Amendment Report for the Application of a Substantive Amendment to the Environmental Authorisation issued for the development of the 140 MW Sutherland Wind Energy Facility, Sutherland, Northern and Western Cape Provinces

DRAFT AMENDMENT REPORT

**AMENDMENT 3. COMMENT & OPINION ON THE ECOLOGICAL IMPACTS ASSOCIATED WITH AMENDMENTS TO THE TURBINE SPECIFICATIONS FOR THE SUTHERLAND WIND ENERGY FACILITY NEAR SUTHERLAND IN THE NORTHERN AND WESTERN CAPE PROVINCE.**

**ADDENDUM TO THE AVIFAUNAL IMPACT  
ASSESSMENT CONDUCTED FOR THE PROPOSED  
SUTHERLAND WIND ENERGY FACILITY (WEF)  
NEAR SUTHERLAND,  
NORTHERN CAPE PROVINCE**

Figure 1: Changes in specifications of turbine dimension

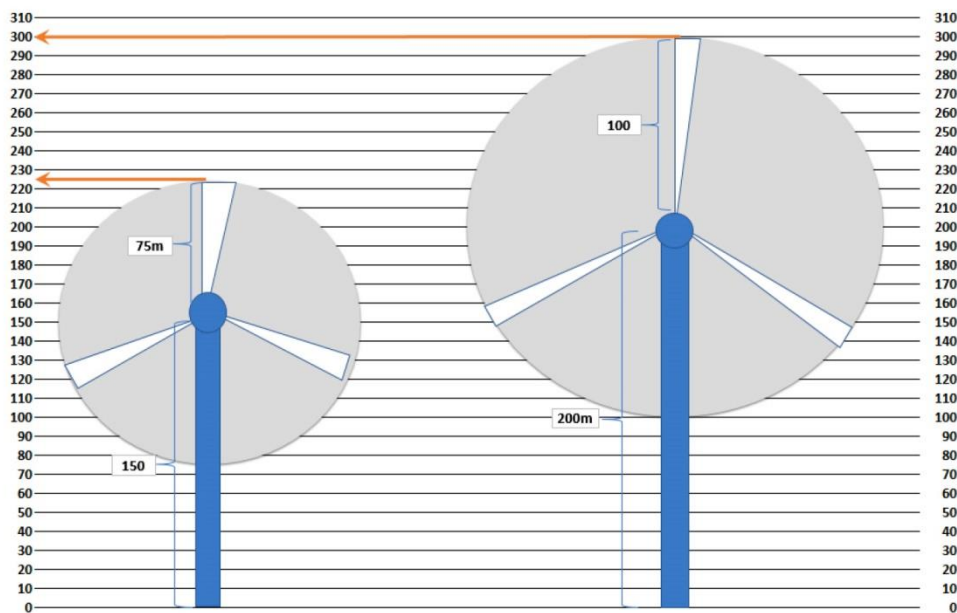
The main negative impact of turbines on bats is the encroachment of air space where bats forage or commute. Table 2 and Figure 1 indicate the increase in the volume of the total sweep area, if turbine sweep is calculated as a sphere. For example, would 39 turbines be installed, with a hub height of 200 m and a rotor diameter of 200 m, there will be a 65,08% increase in sweep area. The lowest point of the sweep of the turbine blades is also indicated, as this could have an impact on bat mortality, see Section 1.1.

- A maximum amount of 39 turbines, with a hub height of 200 m and a rotor diameter of 200 m, is proposed within the provided total output of 140 MW. If more than 39 turbines with these specifications are installed, then mitigations as described in Table 3 will be applicable. Would smaller turbines be deployed, more turbines may be installed, but with agreement of a bat specialist.

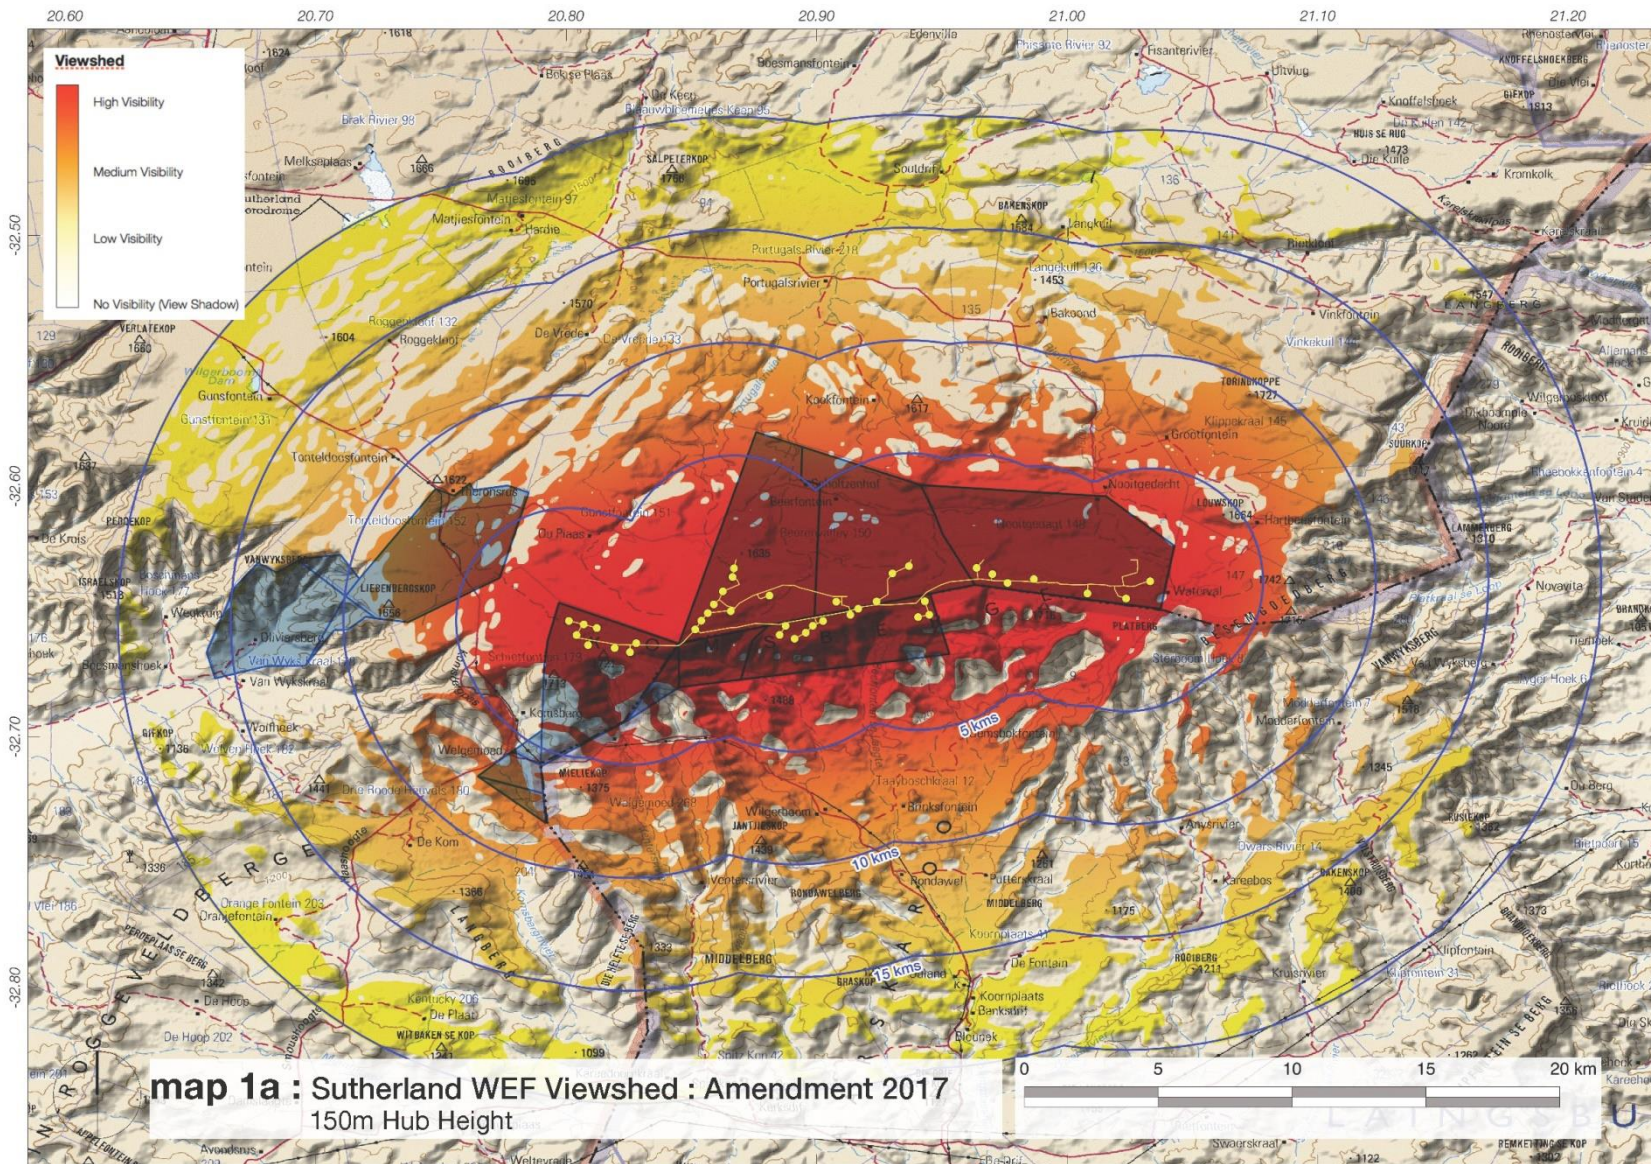
A revised viewshed for the larger turbines has been prepared to determine the visual exposure on the surrounding landscape and receptors, and whether there would be any increase in visual impact significance, (see Map 1b).

Receptors in the form of surrounding farmsteads that were previously in a view shadow, such as Kookfontein, would now fall within the viewshed of the proposed wind farm. However, distance is a mitigating factor.

map 3 : Sutherland WEF Escarpment Edge Setbacks : 500m - 660m

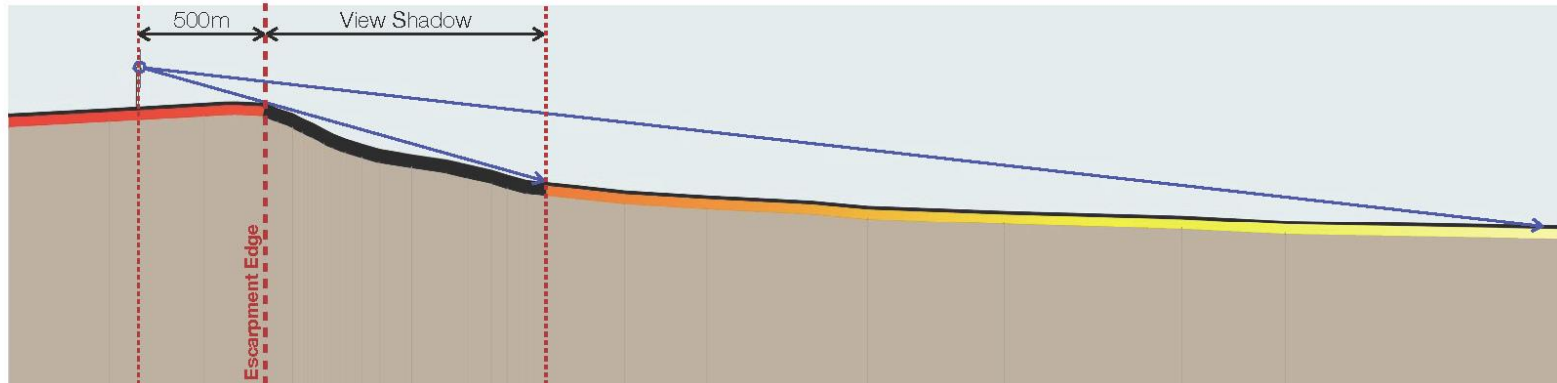
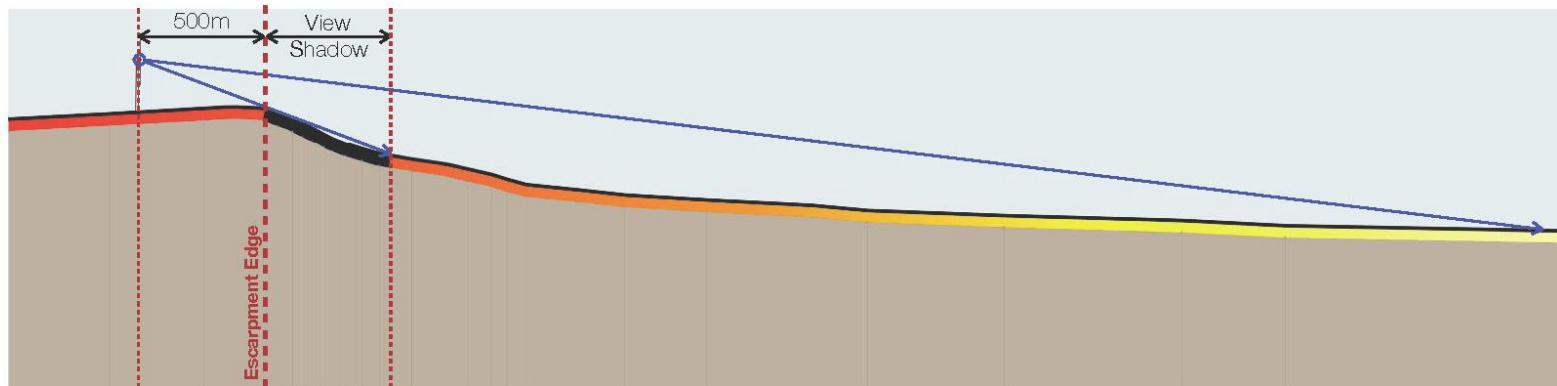
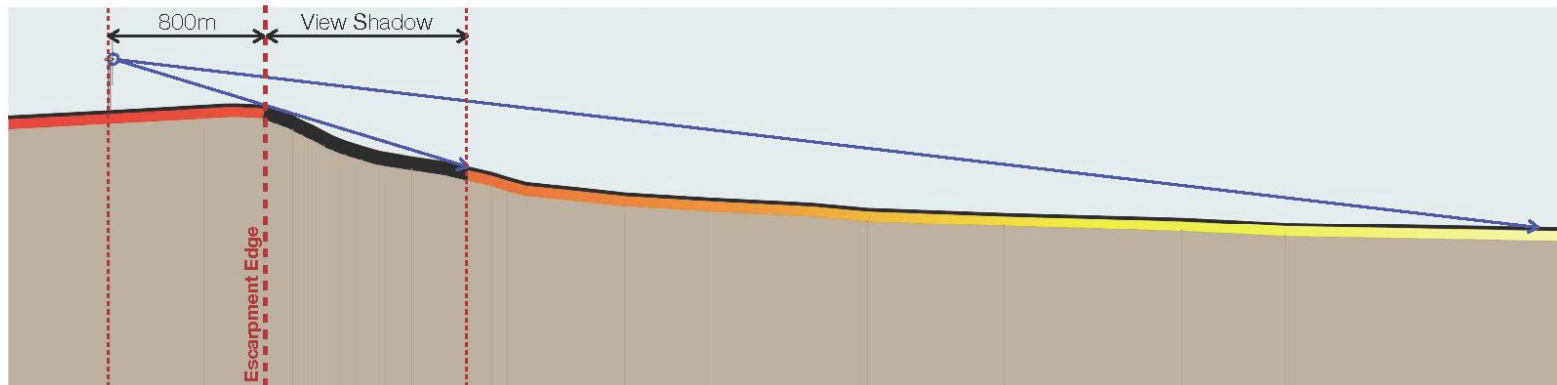
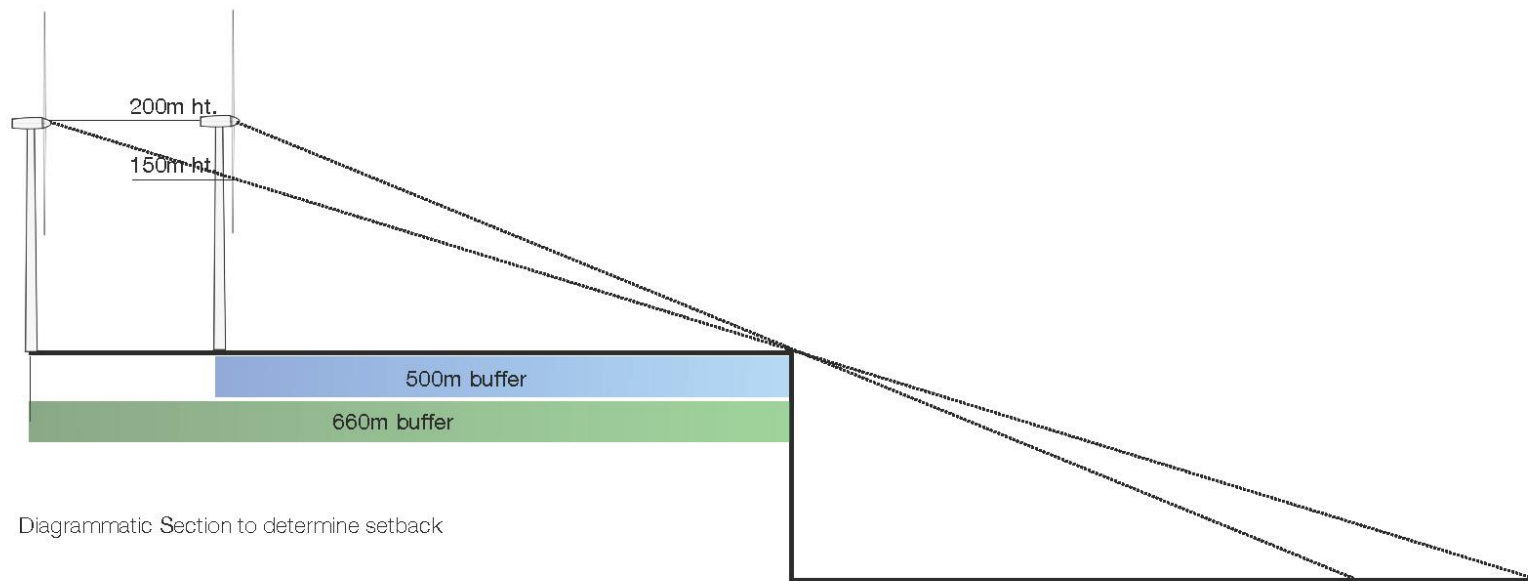
150m Hub Height set back 500m from Escarpment Edge

200m Hub Height set back 500m from Escarpment Edge

200m Hub Height set back 800m from Escarpment Edge

A comparison of the combined viewsheds of the 3 proposed wind farms for the Amendment 2 layout and the current layout is illustrated in Maps 2a and 2b. The difference in visual exposure between these two is shown in Map 2c. Again, the cumulative difference in visual exposure is fairly minimal, but the visual effect on the Komsberg escarpment scenic resource would increase. The cumulative visual effect could be partly offset by increasing the visual buffer from the edge of the escarpment to 660m.
